Re: Edgewater proposal

To: Plan Commission Members
From: Peter Ostlind
Re: Edgewater Redevelopment Proposal
Date: February 4, 2010

Commentary on Edgewater UDC 1/20/10 and 2/3/10 Submissions and Handout

Subject: Edgewater Hotel Redevelopment

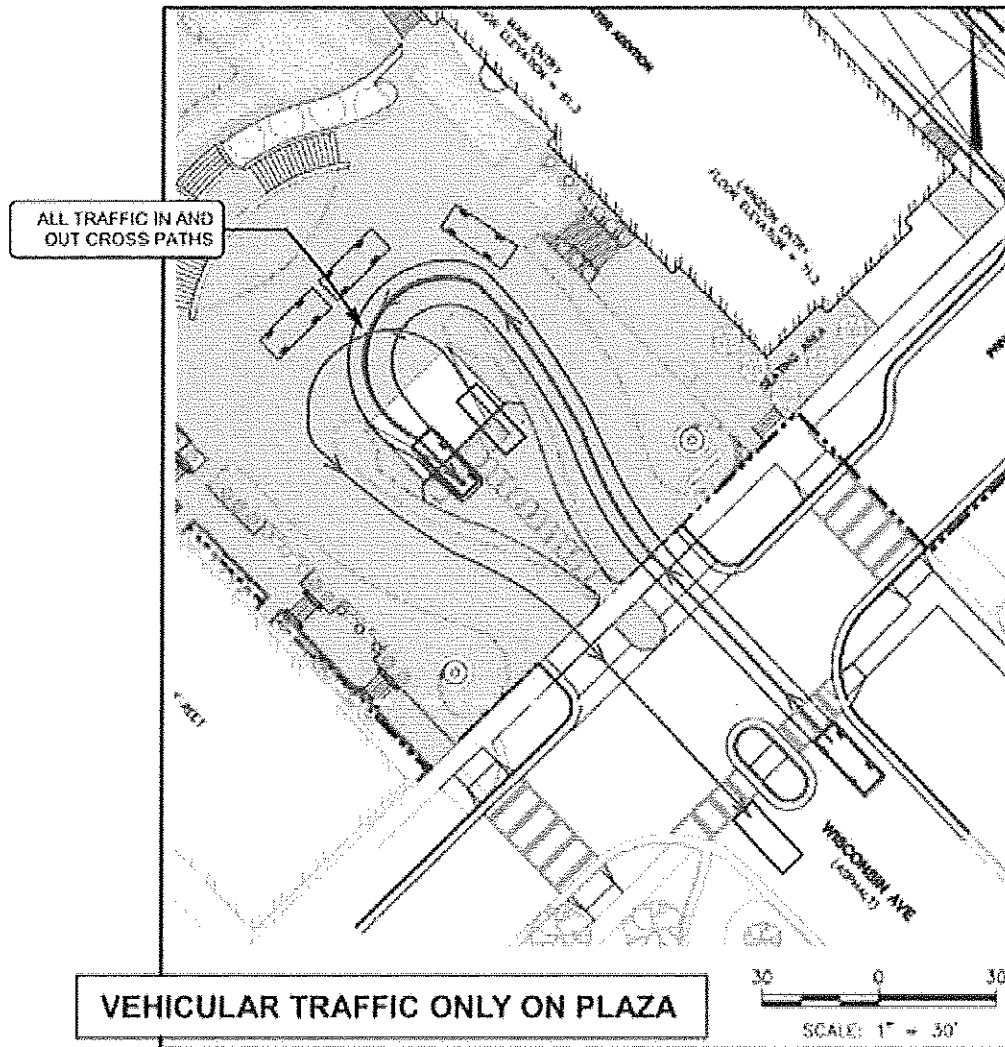
The second subject was the long pier with the platform on the end and the tiki bar. This also was not permissible for a number of reasons. The wide platform on the end of a pier is not something that the DNR will permit and there are issues with the length that the DNR does not have sufficient information about to be able to assure them that anything like a pier of that length could be built. They told them they would be willing to work with them after they found out what the depth of waters were in that area, and certainly they could build a pier of some length although they should not count on a pier with the length of the one that they had shown in their rendering.

PARKING RAMP ENTRANCE ILLUSTRATION

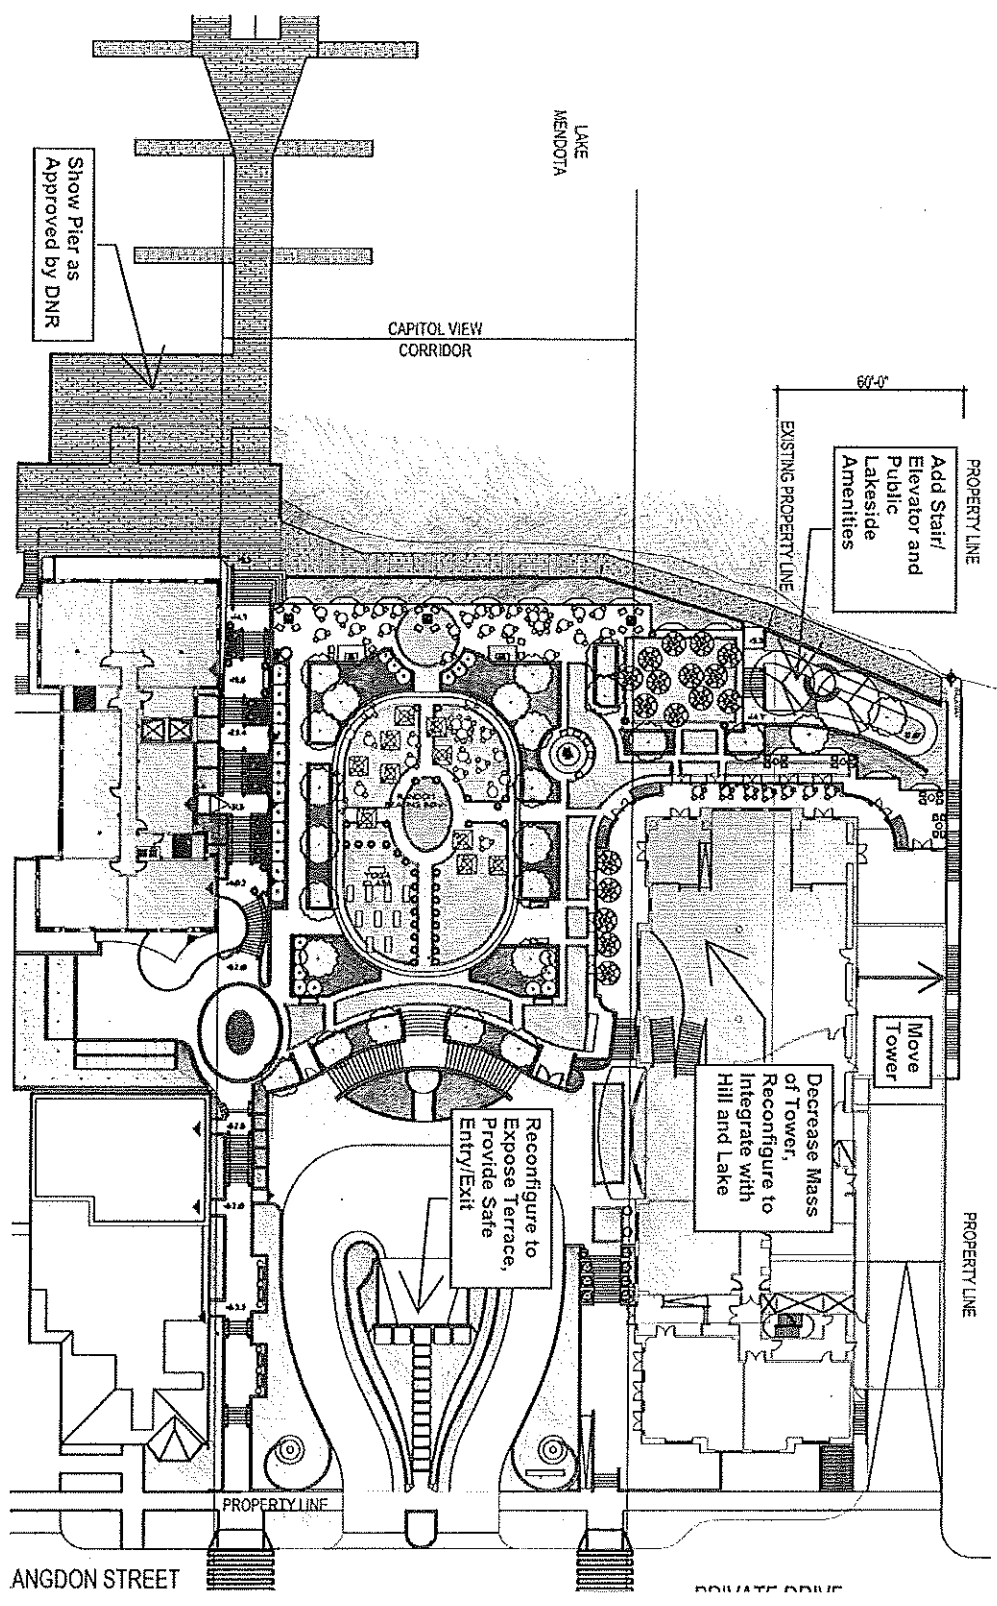
The current configuration of the entrance to the parking ramp creates a significant bottleneck. All traffic entering and leaving the parking ramp across each other's pathway at a critical stage in the and maneuvering area. Visibility of vehicles leaving the ramp is especially impaired. *The auto court needs reconfiguration.* (see "PARKING RAMP ENTRANCE ILLUSTRATION" at the end of this document)

Wisconsin Avenue Facade Comparison @ 1" = 30'
 The Masonic Temple - Quisling Towers
 December 9, 2009

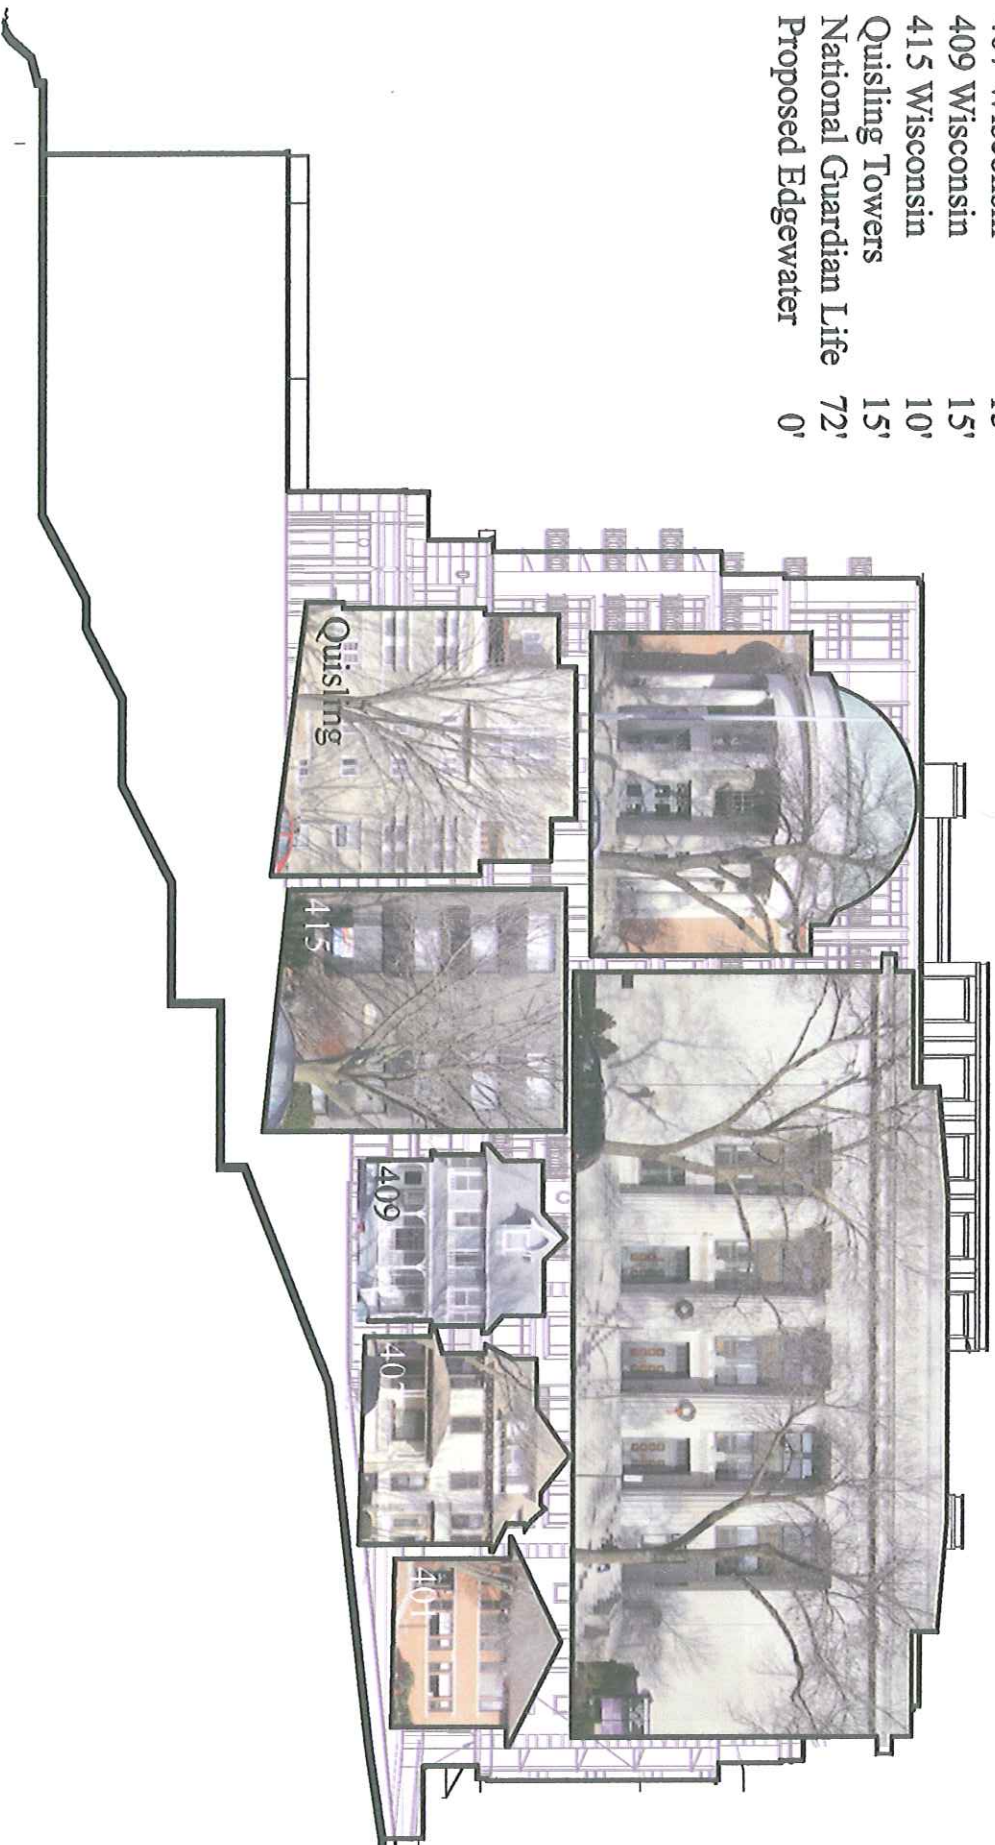
Wisconsin Avenue Setbacks	
The Masonic Temple	18'
Christ Scientist	15'
401 Wisconsin	8'
407 Wisconsin	15'
409 Wisconsin	15'
415 Wisconsin	10'
Quisling Towers	15'
National Guardian Life	72'
Proposed Edgewater	0'
